**Subject: MHI's 1<sup>st</sup> Response to US-APWR DCD RAI No. 514-4040 Revision 2**

**MHI's 1<sup>st</sup> Response to US-APWR DCD RAI No. 514-4040 Revision 2**

**US-APWR Design Certification  
Mitsubishi Heavy Industries  
Docket No. 52-021**

**RAI NO.:** NO. 514-4040 REVISION 2  
**SRP SECTION:** 15.06.05 – LOSS OF COOLANT ACCIDENTS RESULTING FROM SPECTRUM OF POSTULATED PIPING BREAKS WITHIN THE REACTOR COOLANT PRESSURE BOUNDARY  
**APPLICATION SECTION:** DCD CHAPTER 15.6.5. SMALL BREAK LOCA  
**DATE OF RAI ISSUE:** 12/17/2009

Figure RAI-15.6.5-70.1 Primary Pressure

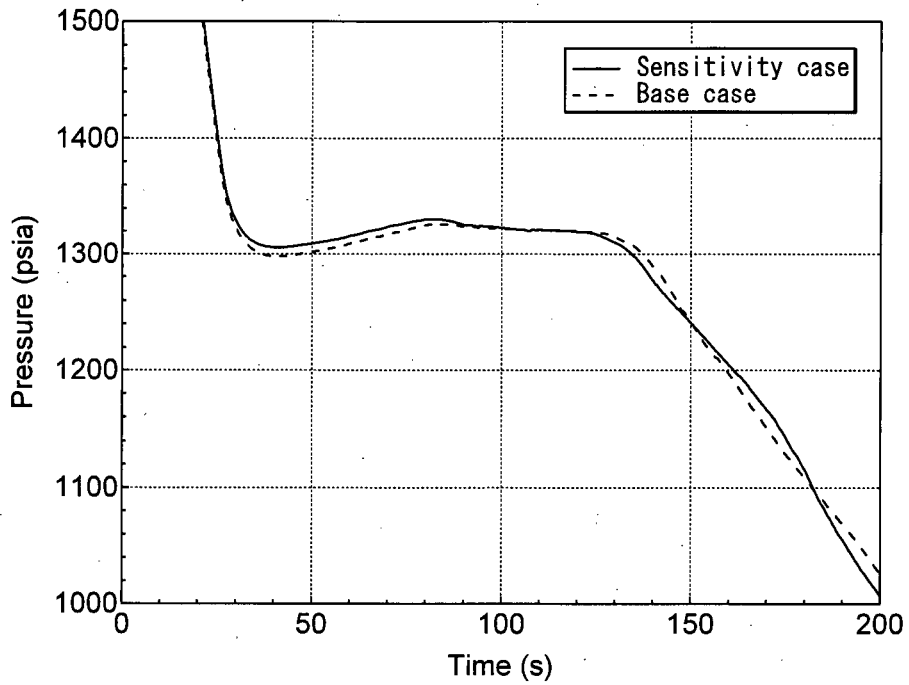
The loop nodding sensitivity study presented in Section 5.4.2 shows that loop seal clearance is predicted to occur sooner with the finer nodding model, resulting in no heatup (PCT).

Provide a comparative description of the loop seal period for both the base case and the sensitivity case, including the times for loop seal clearance and expanded figures of applicable parameters around the time period of loop seal clearance.

Expanded figures around the time period of loop seal clearance are shown in Figures RAI-15.6.5-70.1 to 10. Figure RAI-15.6.5-70.1 represents the primary pressure transient, and is the expanded figure of Figure 5.4.2-1 in Ref.1. Figure RAI-15.6.5-70.2 represents the downcomer collapsed level, and is the expanded figure of Figure 5.4.2-8 in Ref.1. Figure RAI-15.6.5-70.3 represents the core and upper plenum collapsed levels expanded from Figure 5.4.2-10 in Ref.1. Figure RAI-15.6.5-70.4 represents the PCT transient expanded figure of Figure 5.4.2-11 in Ref.1. Figures RAI-15.6.5-70.5 and 6 represent collapsed level of the broken loop crossover leg downhill side and uphill side, respectively. Figure RAI-15.6.5-70.7 represents the broken loop crossover leg vapor flowrate. Figures RAI-15.6.5-70.8 and 9 represent collapsed level of the intact loop crossover leg downhill side and uphill side, respectively. Figure RAI-15.6.5-70.10 represents the intact loop crossover leg vapor flowrate.
